**AGENDA  
PLANNING COMMISSION  
116 WEST NEEDLES  
BIXBY, OKLAHOMA  
March 25, 2015                      6:00 PM**

**To:** Bixby Planning Commission  
**From:** Erik Enyart, AICP, City Planner   
**Date:** Tuesday, March 24, 2015  
**RE:** Report and Recommendations for:  
PUD 81 Major Amendment # 1 – “Chateau Villas PUD” – Larry Kester of Architects Collective

P1

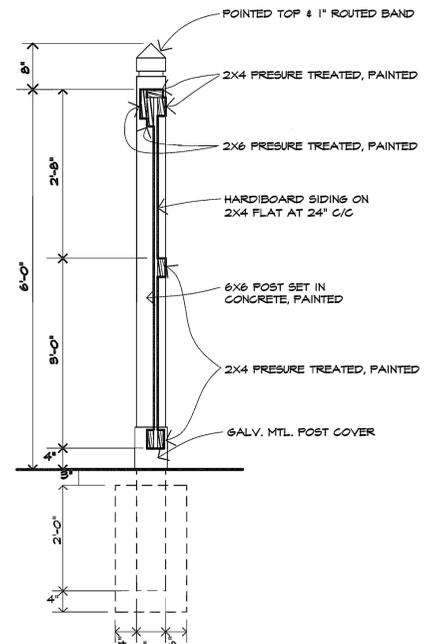
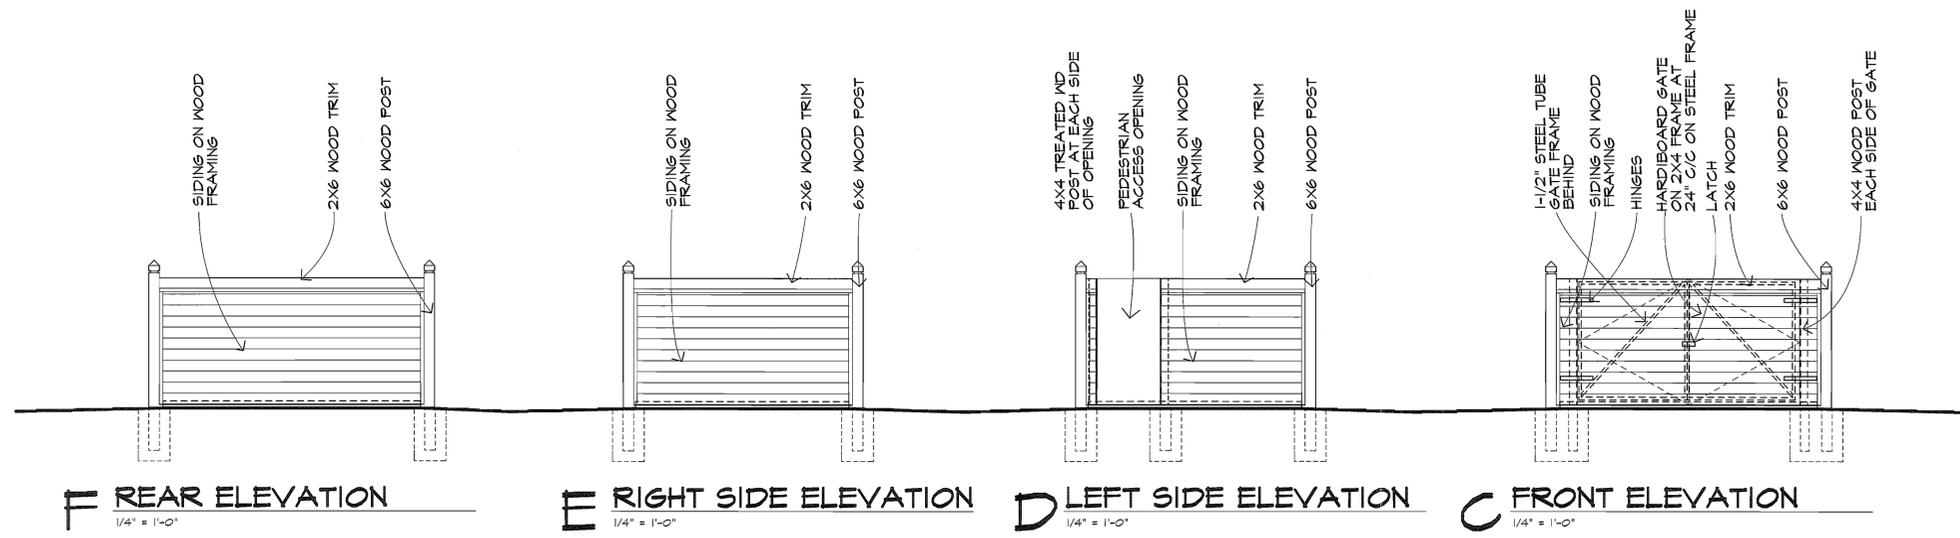
PUD 81 allows, for DA B, 375 units total with a minimum of 75 1-bedroom and 300 maximum “Two+” bedroom. Per the “Unit Mix” table on “Site Plan” drawing P1, the PUD restrictions will be met. Interior floorplans, such as would allow for verification of unit schedule and such as were included with the Encore on Memorial development, have not been provided. These should be included with the PUD Detailed Site Plan.

- (1) the "Site Plan" drawing P1 should be renamed "Conceptual Site Plan for Chateau Villas" Exhibit B,
- (2) the elevations drawings should have distinct drawing names and numbers,

The key codes used on the building elevations (e.g. “A1/A2 3/4”) do not match those used on the site plan (e.g. “A1/A2.3”). The “Building Footprints” legend on the site plan does not explain why some portions of certain buildings are shaded (likely indicative of building parts extending to the fourth story). This should be labeled to remove the necessity of guesswork. Certain building types may be missing, and should be added in that case.

12. The "Building Footprints" legend on "Site Plan" drawing P1 includes symbols customarily associated with exterior light fixtures, which would appear to be wall-mounted lights in this case. These are appropriate on BSP 2015-04 "Site Lighting Plan" drawing P1-1 (or perhaps, "P1-L"), but should be removed from P1.

13. Please identify areas proposed for landscaping consistent with the original Exhibit B (e.g. "landscaping," "sod," "grass," etc.).
14. The original "Site Plan" drawing P1 showed "Combination Ornamental Metal and Wood Fence," but the version received 03/24/2015 now shows these fence sections as simply "wood fence." The original Exhibit B showed these fence sections as "Combination Wood and Ornamental Iron Fence." Please reconcile the fence plans shown on P1 with the original Exhibit B, or explain discrepancies. Upgrade substitutions will be acceptable, but downgrade substitutions and removals will not.

29. Please resolve text/linework congestion along the 130' PUD boundary shared with *Houser Addition* and elsewhere throughout the "Site Plan" drawing P1.
